**Wisconsin Public Service Corporation**  
 (a subsidiary of WPS Resources Corporation)  
 Kewaunee Nuclear Power Plant  
 North 490, Highway 42  
 Kewaunee, WI 54216-9511  
 920-388-2560

Docket 50-305  
 Operating License DPR-43  
 Kewaunee Nuclear Power Plant  
**Additional Information for Proposed Amendment 164 to the Kewaunee Nuclear Power Plant  
 Technical Specifications: Extension of Use Through Cycle 24 of the Length Based Pressure  
 Boundary Definition for Westinghouse Steam Generator Hybrid Expansion Joint Sleeved Tubes**

Steam Generator A  
 Distribution of Parent Tube Indications From the 1998 Refueling Outage

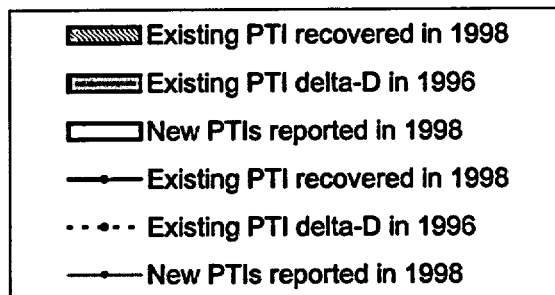
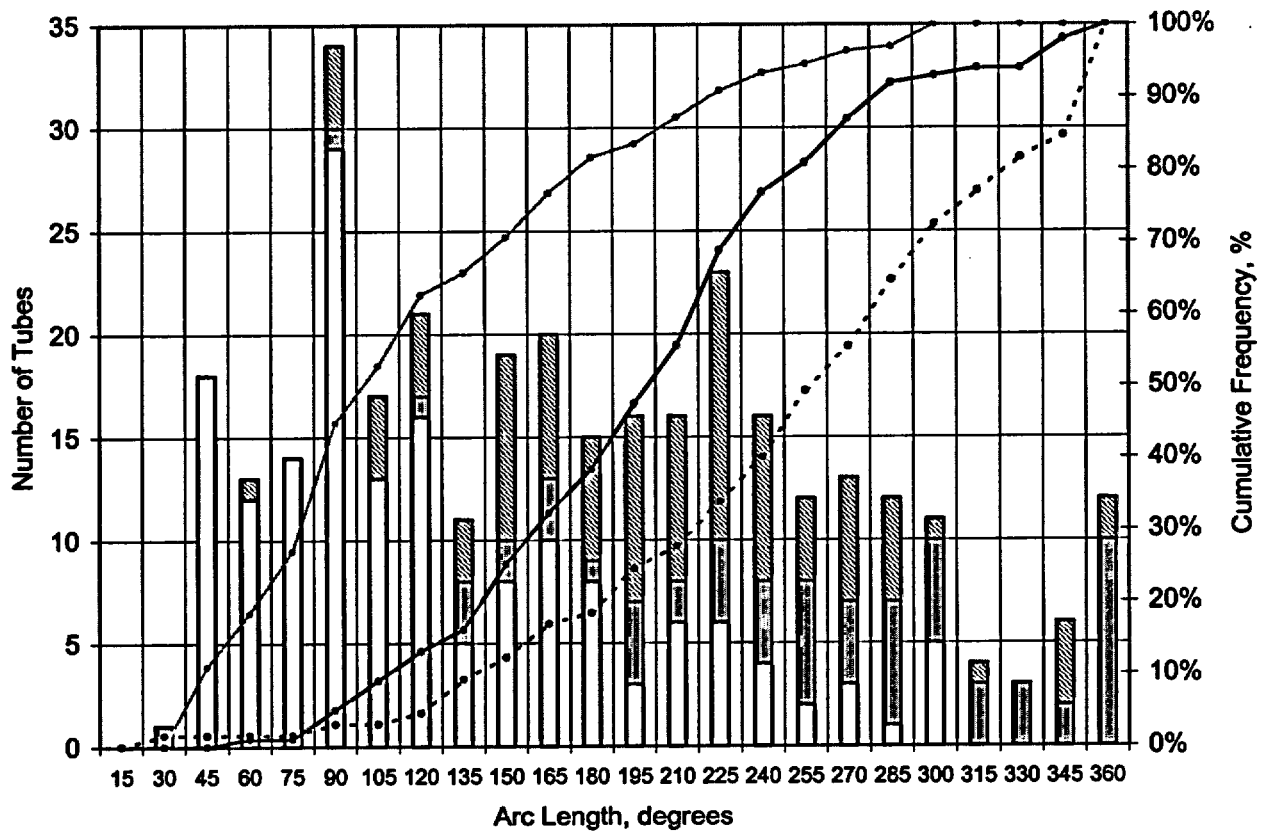
*Provide a frequency distribution of the extent (arc length) of circumferential PTIs in the hybrid expansion joints from previous inspections.*

Table 1 provides the mean reported arc length, largest reported arc length, number reported during the 1998 RFO, and number currently in service for cycle 23 for each population of PTIs. The frequency distribution of PTIs from the 1998 inspection is provided in Figure 1 for SG A and Figure 2 for SG B.

Arc Length Change per EFPY

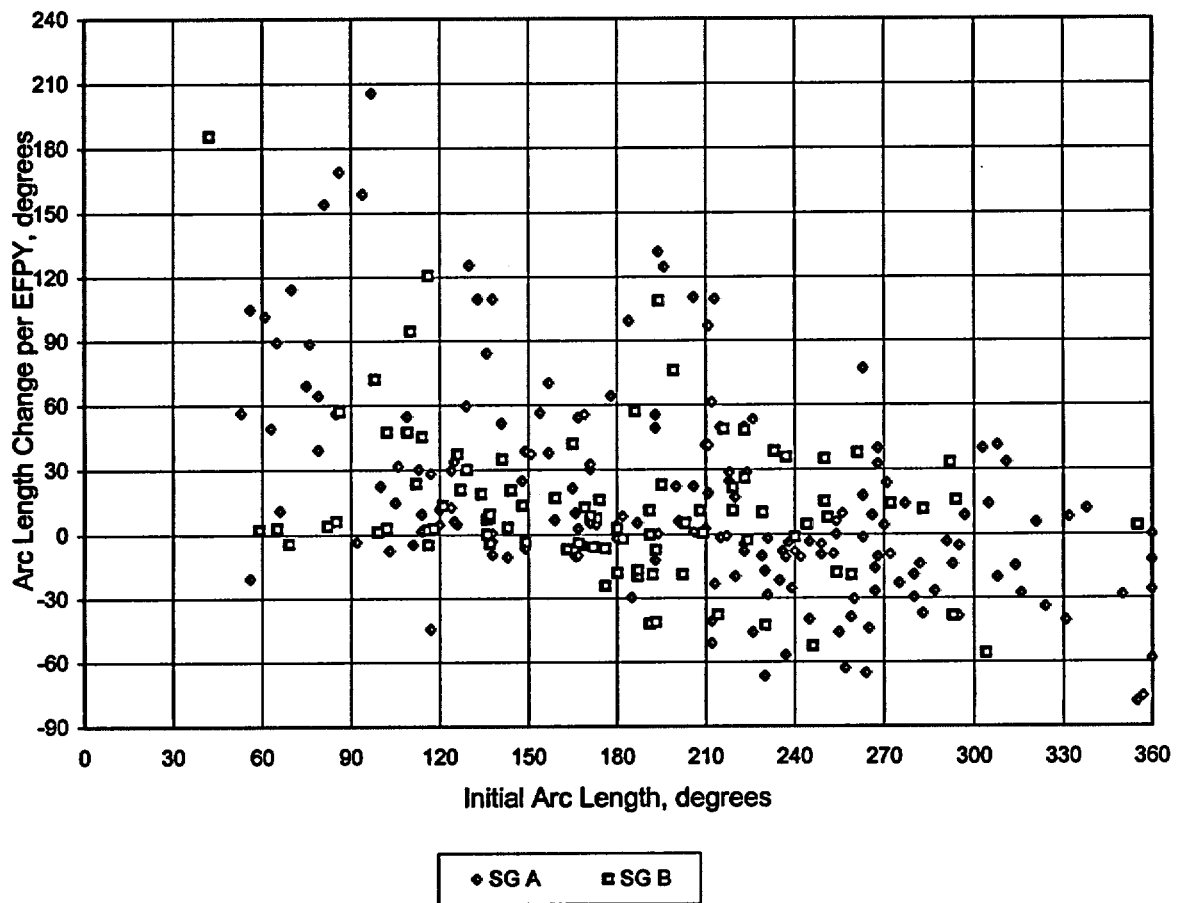
*Provide an analysis of the circumferential PTI growth rate based on previous inspection data.*

A total of 262 tubes are contained within these two populations. Arc lengths from the 1996 and 1995 inspection data were measured consistent with the methodology used in measuring arc lengths from the 1998 inspection data. Changes in arc lengths between the 1998 RFO and either the 1996 RFO or 1995 RFO were normalized in terms of arc length change per effective full power year (EFPY). A scatter plot showing the change in arc length per EFPY as a function of the initial PTI arc length is shown in Figure 3. The mean growth rate per EFPY is calculated in 30 degree bins, treating the negative arc length differences shown in Figure 3 as zero. The results are shown in Table 2. Similar growth rates were observed for both SGs, with higher growth rates per EFPY observed for the smaller arc lengths.
